NORTHEAST UTILITIES

Millstone Nuclear Power Station, Unit No. 3
Structural and Geotechnical
Engineering Branch
Additional Information in Response
to Confirmatory Items

Attachment I

Revised Responses to Structural Audit Items:

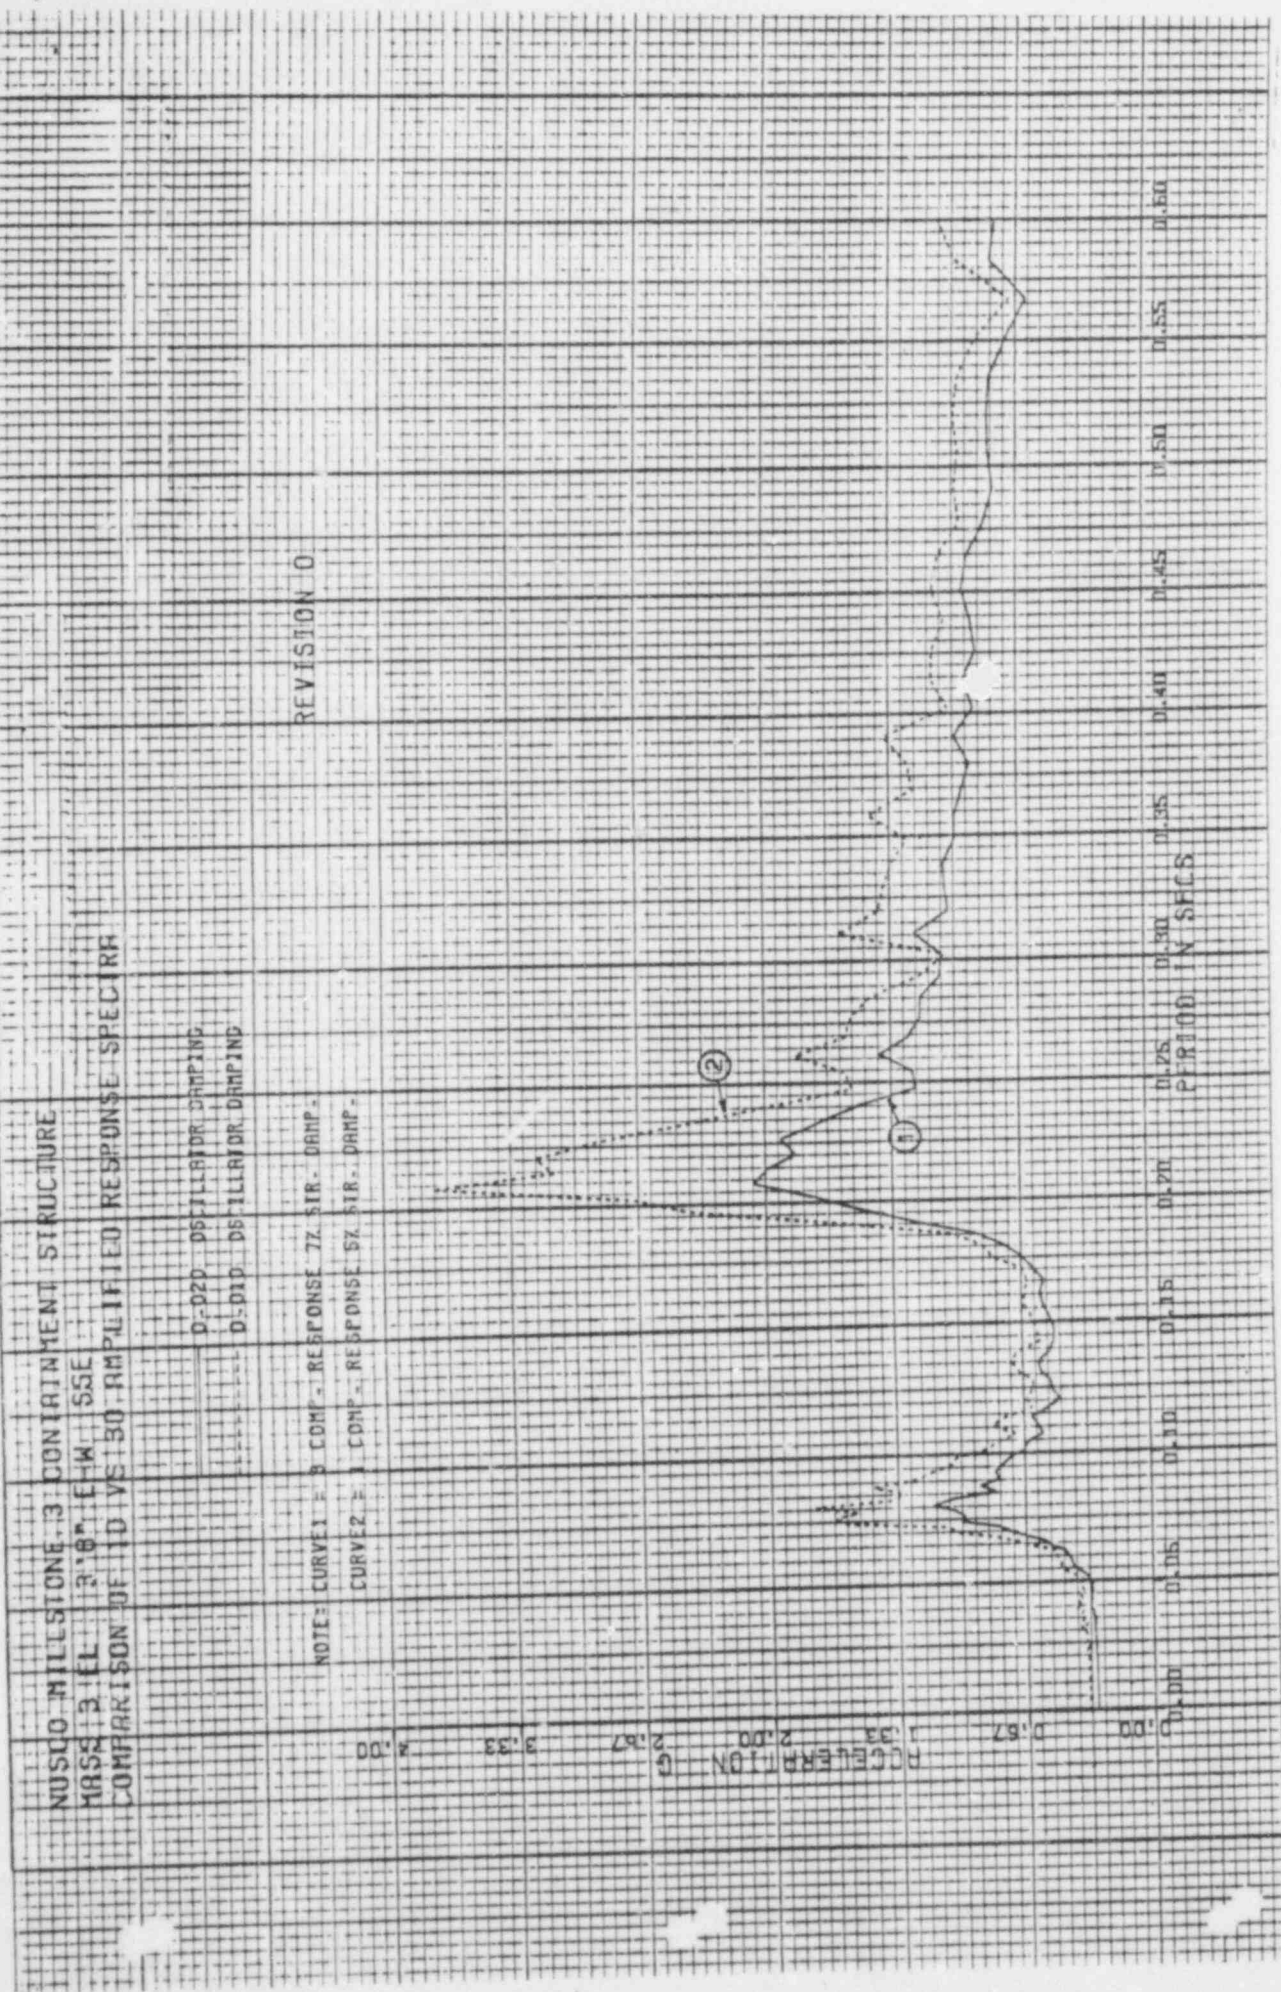
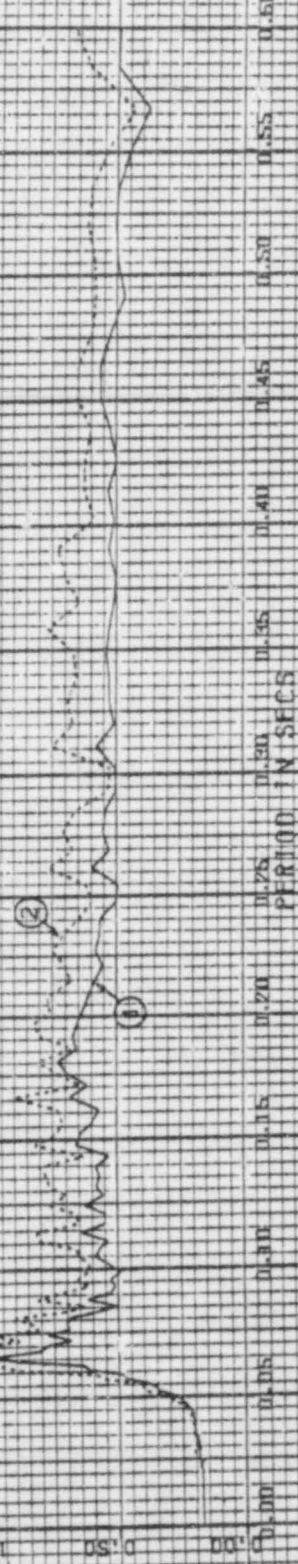
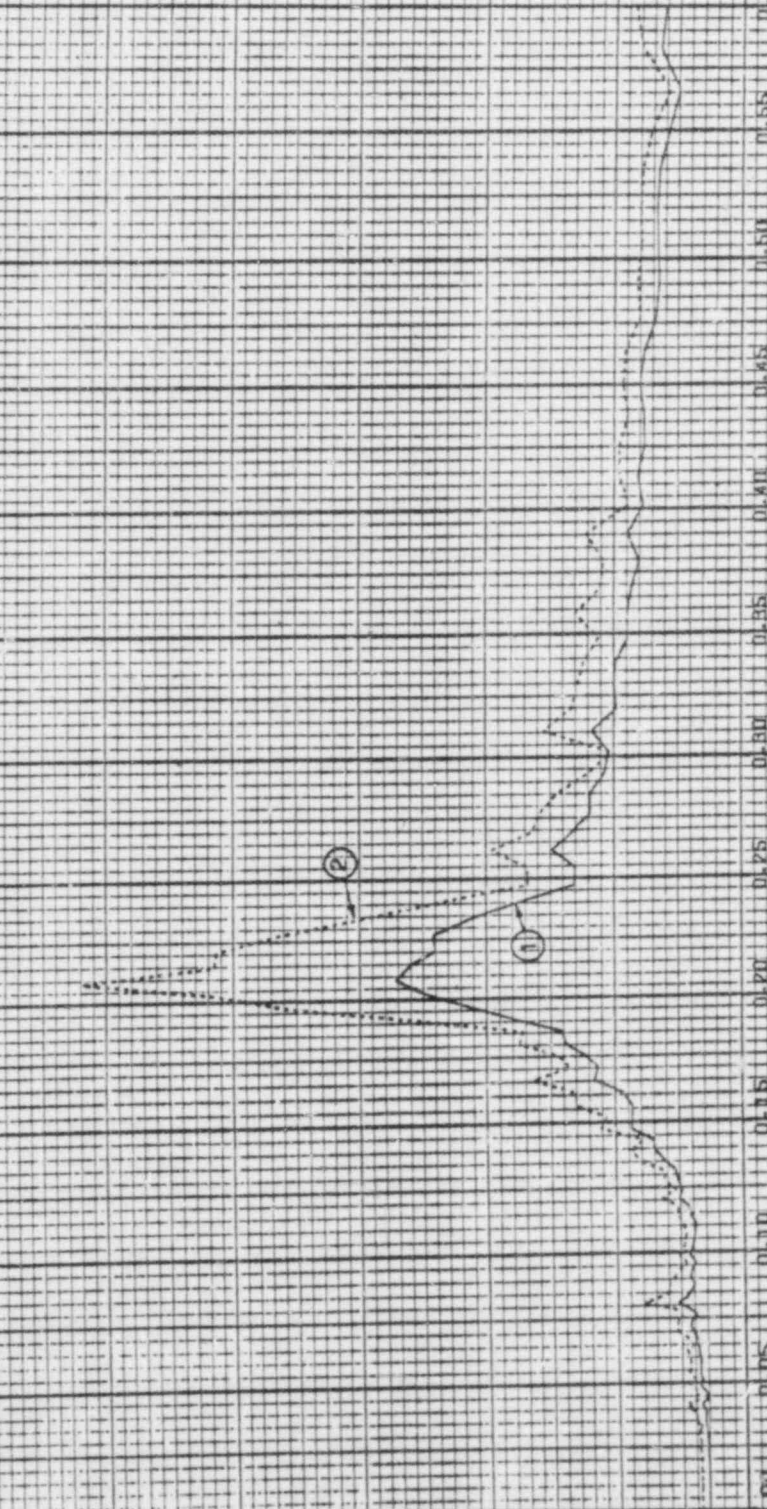
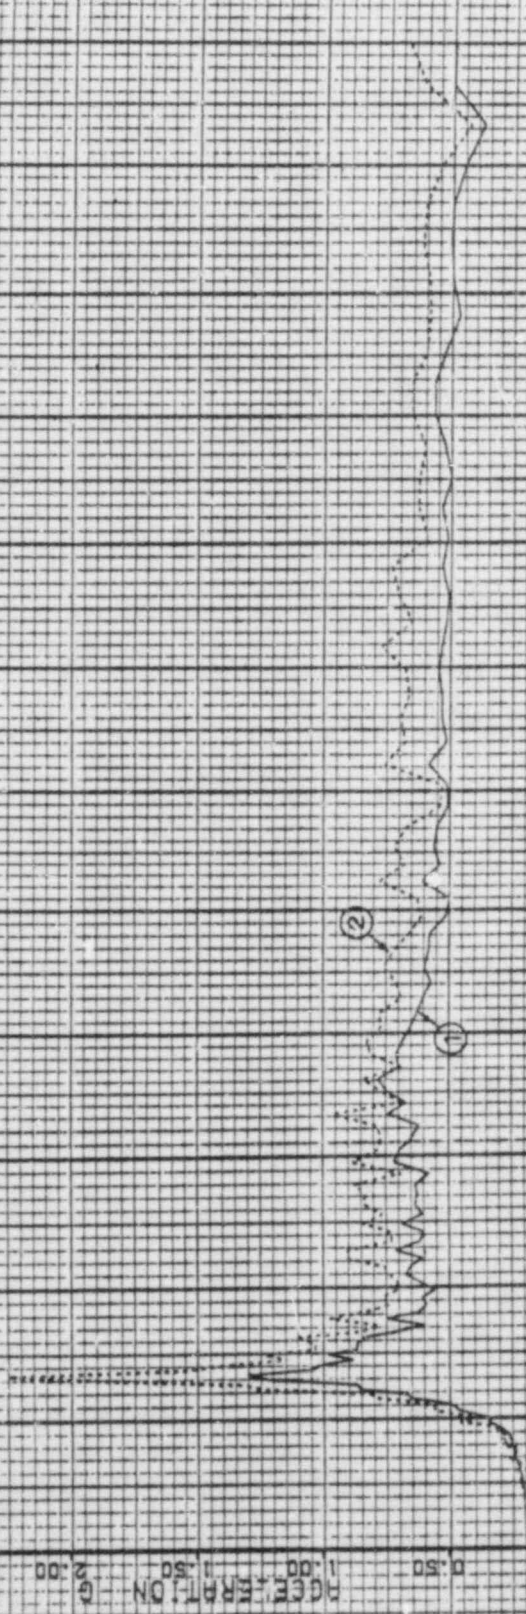
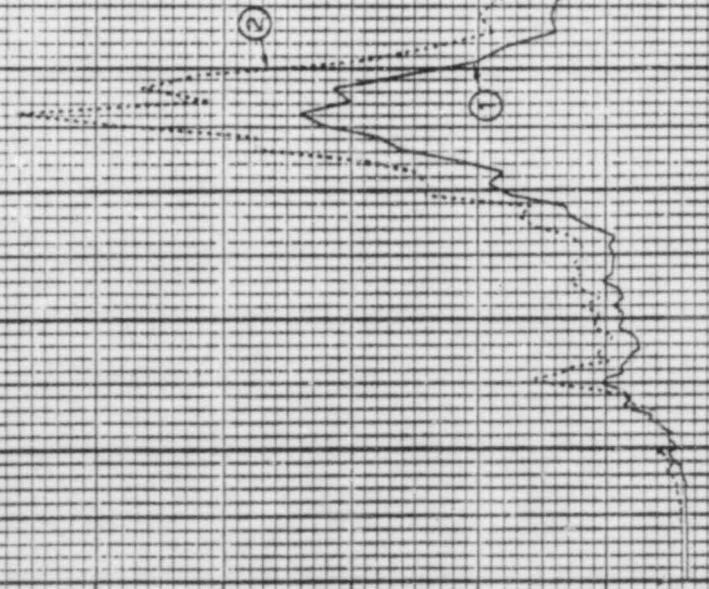
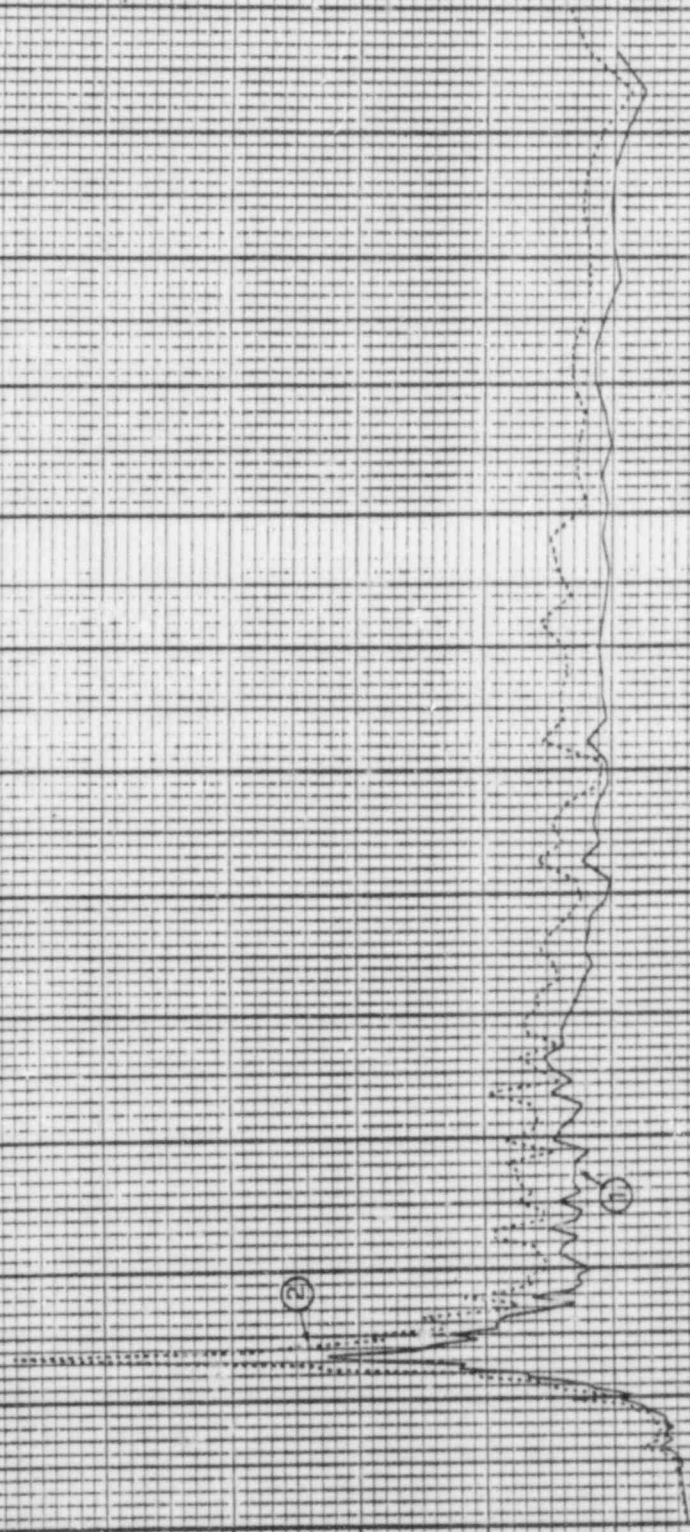
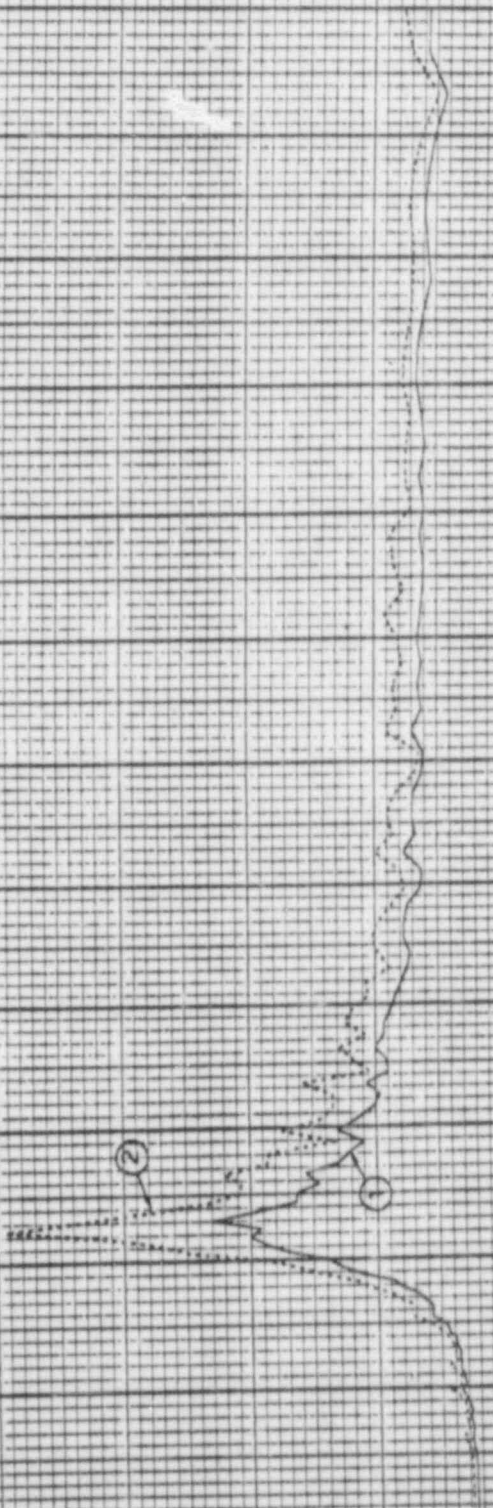
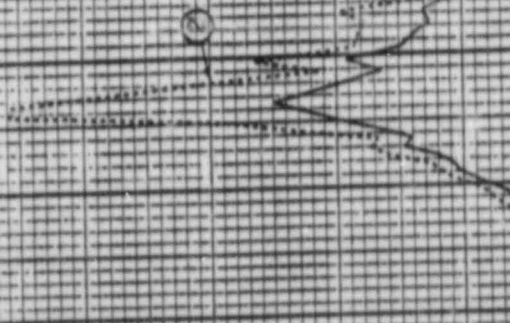
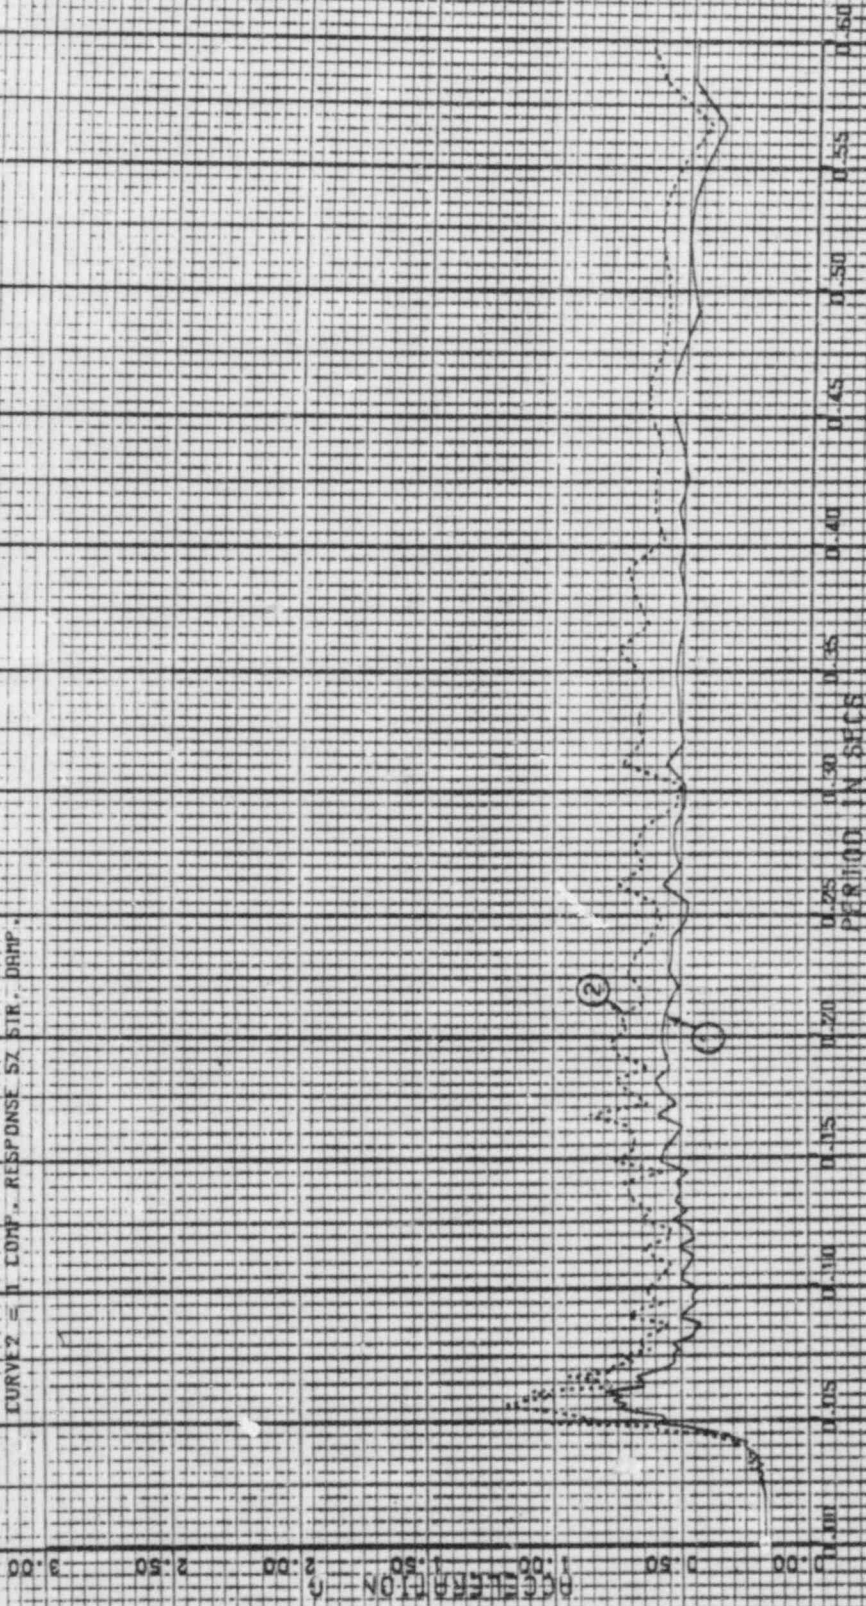
ITEM 27: Provide Justification for Generation of ARS Based Upon One
- Component of Input Motion

The method and criteria used in the generation of ARS for Millstone Unit 3 are inherently conservative. Conservative damping values are used both for structures and equipment. The conservatism in those damping values can be seen when they are compared with the recognized conservative values in Regulatory Guide 1.61. In addition, the input time history used to generate the ARS envelopes the design response spectrum as shown on Figures 3.7B-3 through 3.7B-8 of the FSAR.

To evaluate the conservatism of the one-component ARS curves, a study was conducted to provide a comparison between ARS developed for the SSE condition using:

1. One-component response with 5 percent structural damping and 1 percent oscillator damping.
2. Three-component response (SRSS of the three ARS components) with 7 percent structural damping and 2 percent oscillator damping.

To assure a study representative of all Category I buildings, the Containment Structure, Auxiliary Building, and Fuel Building were evaluated. The Auxiliary Building is representative of all Category I buildings with little coupling, and the Fuel Building is representative of buildings with a large degree of coupling. In every case, the ARS were generated for SSE condition using the three-component response and are enveloped by the response spectra that have been used in piping and equipment qualification.

The attached amplified response spectra curves used in the study are provided for the above buildings in the direction of E-W, N-S and vertical excitation are as follows:

Therefore, it is concluded that the one-component ARS curves developed for all Millstone Unit 3 Category I buildings are conservative with respect to the three-component ARS curves.
